APPLICATION NO.	FILING DATE	FIRST NAMED INVENTOR	ATTORNEY DOCKET NO.	CONFIRMATION NO.
10/820,030	04/08/2004	Atsushi Murayama	0951-0136PUS1	7584

Office Action Summary	Application No. 10/820,030	Applicant(s) MURAYAMA, ATSUSHI	
	Examiner Luis F. Garcia	Art Unit 2613

DETAILED ACTION

Fig. 1.

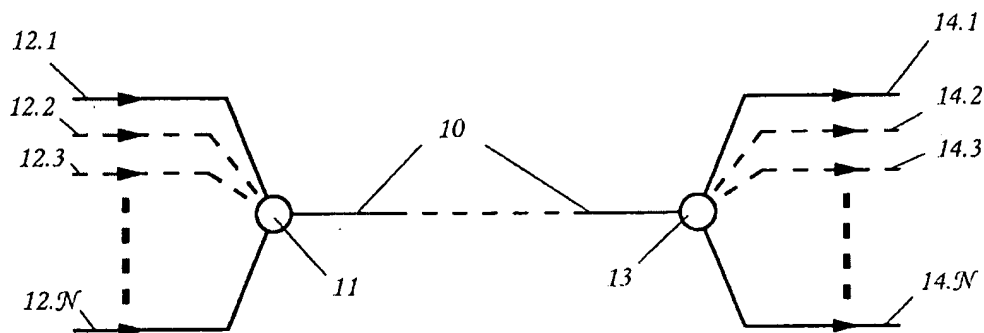
King further discloses comprising, as one or more means for transferring one or more clock synchronization signals from one or more input sides to one or more output sides (**FIG. 1 and col2 ln34-63 in which the clock signal is transferred from the input side (e.g 11-multiplexer) to the output side (e.g. 13-demultiplexer))**: transfer of one or more clock synchronization signals simultaneous with one or more signals at at least one of the respective channel or channels through use of the light-receiving element and the light-emitting element transferring one or more signals (**col2 ln34-67 to col3 ln1 and FIGs. 2-10 in which the clock signal is transferred simultaneously with the TDM signal (respective channels) through the use of the light emitting element and the light receiving element, e.g. the TDM signal is amplitude**

at one or more input sides: a light-emitting element transferring one or more signals to at least one of the output side or sides (FIG. 1 (11-multiplexer) in which the multiplexer transfers OTDM signals to the output side(s) (e.g. to the demultiplexer-13). NOTE: a light emitting element for transmitting an optical TDM signal is an inherent part of the system, e.g. Mach Zehnder (optical type modulator) is used to received and decode the TDM signal; thereby, making the transmitted TDM signal an optical TDM signal created by a light-emitting element); and

one or more level coupling means for carrying out level coupling with respect to one or more input signals at at least one of the respective channel or channels so as to impart one or more changes in one or more optical intensities at the light-emitting element (FIGs. 1,7 and col2 ln34-51 in which the TDM signal is amplitude modulated (via level coupling means)(e.g. change of optical intensity at the light emitting element) via a timing signal-col3 ln31-36) and for causing same to be transferred to at least one of the output side or sides (FIG. 1 in which the amplitude modulated TDM signal is transferred to the output side (e.g. to the demultiplexer-13));

by the light-emitting element (**FIG. 1 (13-demultiplexer)** in which the demultiplexer (light receiving element) receives the amplitude modulated TDM signal (signal(s) imparted with changes in optical intensity produced by the light-emitting element). **NOTE: the demultiplexer consist of a Mach-Zehnder demodulator-col3 In1-19 or optical gates-col2 In64-67 to col3 In1); and**

an input circuit for receiving at least one input signal (**FIG. 1 (12.1-12.N: inputs) in which the inputs inherently receives an input signal from an input circuit, e.g. receives a data signal from the input circuit);**

an output side comprising a first light-receiving element (**FIG. 1 (13-demultiplexer) in which the demultiplexer (light receiving element) is located at the output side);**

a first light-emitting element communicating said time-divided signal from said input side to said output side (**FIG. 1 and col1 ln29-36 and col2 ln11-33 in which an optical TDM signal is transmitted from the input side (e.g. 11-multiplexer) to the output side (e.g. 13-demultiplexer). NOTE: the TDM signal is inherently transmitted via a light emitting element, e.g. light emitting element generates the optical signal); and**

FIG.11 Prior Art

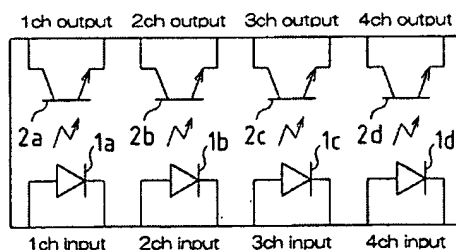
Regarding claim 1, AAPA discloses a multichannel photocoupler (FIG. 11)

at one or more input sides (**FIG. 11 (channel inputs)**); and

a light-emitting element communicating signals to one or more output sides (**FIG.**

11 (output) in which the input sides communicates signals with the output sides);

at one or more output sides: a light-receiving element receiving at least one of signals from the light-emitting element (**FIG. 11 in which the light-receiving elements at the output side (e.g. PD-2a-d) receive signals from the light-emitting elements (e.g. LEDs-1a-c).**

at one or more input sides: a light-emitting element transferring one or more signals to at least one of the output side or sides (**FIG. 11 (LEDs-1a-d) in which the LEDs (light emitting elements) transfer signals to the output side**); and

one or more level coupling means for carrying out level coupling with respect to one or more input signals at least one of the respective channel or channels so as to impart one or more changes in one or more optical intensities at the light-emitting element (**FIG. 11 (LED-1a) in which the LED is inherently intensity modulated in order to transmit channel data to the output as is the basic function of an optical communication system**) and for causing same to be transferred to at least one of the

output side or sides (**FIG. 11 (LED-1A) in which the data from input channel 1 is transferred to the output side (e.g. to output channel 1))**;

at one or more output sides: a light-receiving element receiving one or more signals imparted with one or more changes in one or more optical intensities produced by the light-emitting element (**FIG. 11 (2a-photodiode) in which the photodiode receives the signal produced by the light-emitting element (e.g. signal produced by LED-1a))**).
